BAR Meeting
February 22, 2012

ISSUE: Permit to Demolish/Encapsulate and Addition/Alterations
APPLICANT: Andrea Seward (Allison Thurmond, Agent)
LOCATION: 324 North Patrick Street
ZONE: RB/Residential

**CASE BAR#2012-0020 &
CASE BAR#2012-0021**

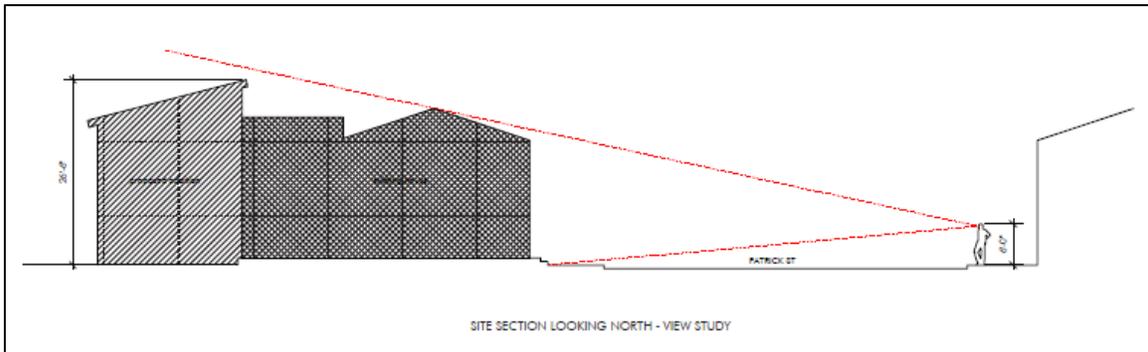
The *Design Guidelines* support additions beyond the roofline of an existing structure only “if the significant architectural character of the house and blockface are preserved.” Although the proposed shed roof addition will be 5’-6” higher than the existing roof on the main block, it will be located 28’ from the front property line (see below.)

Staff and the architect have confirmed that the addition will not be visible from North Patrick Street and will be in scale with the adjacent additions. At the request of Staff, the architect has provided the below section which shows the sight lines of the addition from a pedestrian’s viewpoint on the east side of North Patrick Street.

Staff finds the rear additions are not visible from North Patrick Street and consistent with the *Design Guidelines* and the historic district’s development patterns and therefore recommends that the Board approve the design, as submitted.

Figure 4: Existing and Proposed Rear Elevations

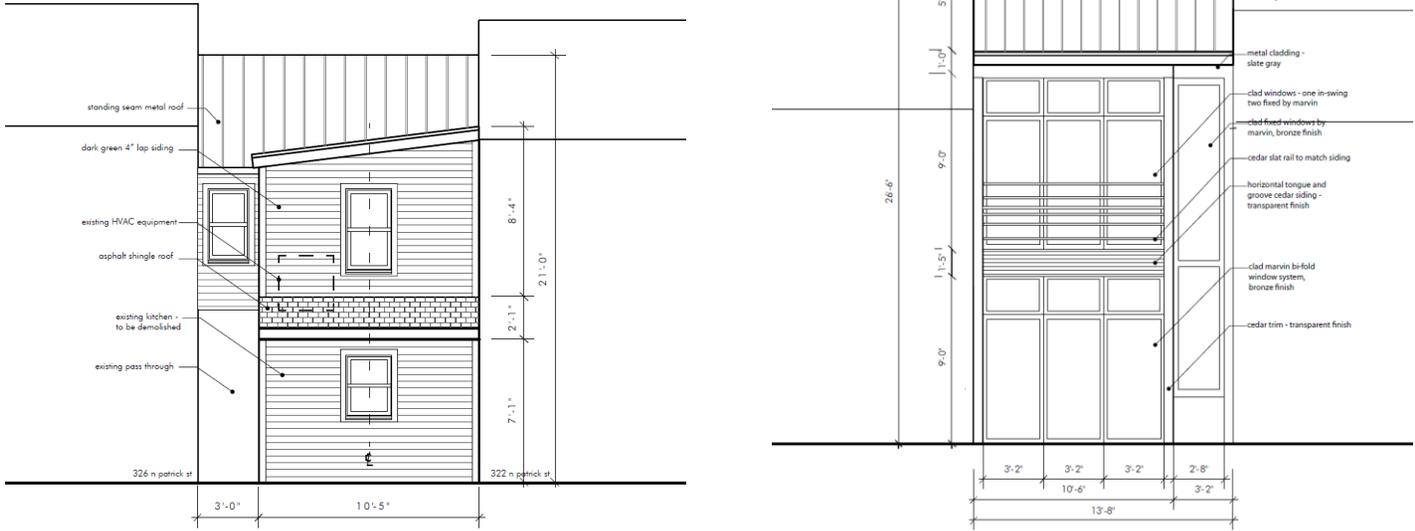
Staff has no objection to the proposed demolition of the one-story, c1940s addition or the encapsulation and demolition of portions of the east (rear) elevations and finds the proposed additions to be compatible with the existing building and surrounding area.

In the opinion of Staff, none of the criteria for demolition and encapsulation are met and the Permit to Demolish/Encapsulate should be granted. Staff has no objection to the proposed demolition of the one-story addition or demolition/encapsulation of the rear walls and finds the proposed additions to be compatible with the existing building. The area proposed for demolition/encapsulation is minimal in scope, located on a secondary elevation, does not remove any portion of the building containing character defining features of uncommon design or historic merit, and does not compromise the integrity of the building as a whole.

Figure 8: Roof Plans

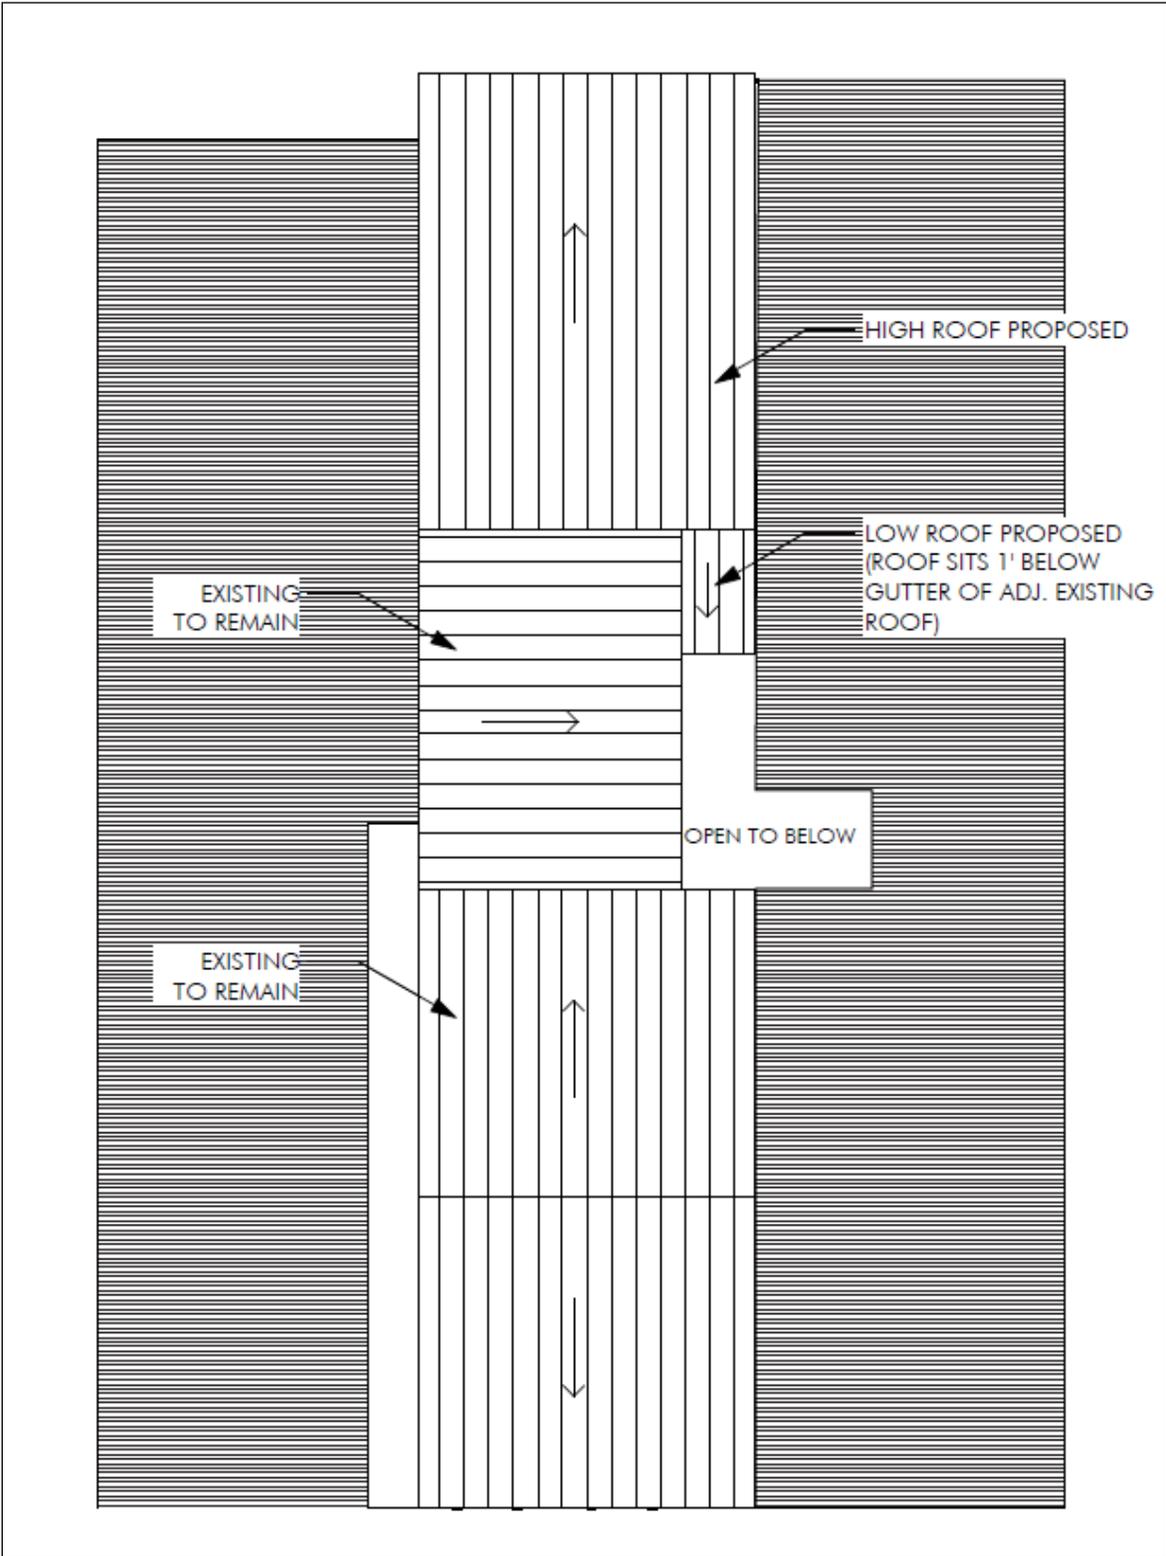
Staff understands the applicant’s desire to replace the entire roof surface and to create a unified roof appearance. However, the pan of the proposed metal roof does not appear to match the width of the existing metal roof on the original block of the house and is not a traditional standing seam design. The proposed metal roof has a 1 1/2” x 1 1/2” batten seam

which is more typical of early 20th century Prairie Style architecture. Staff has no objection to a factory finished, snap lock seam roof material and supports this more modern roofing pattern on the addition but strongly recommends that the pan width and the shape and height of the seam match the existing roof conditions for the portion of the roof visible from North Patrick Street.

1. That the new windows on the front façade will be double-hung, SDL 2/2 wood windows in conformance with the City of Alexandria's *Window Policy*
2. That the pan width and standing seam height and profile at the new metal roof pan match the existing metal roof on the main structure.
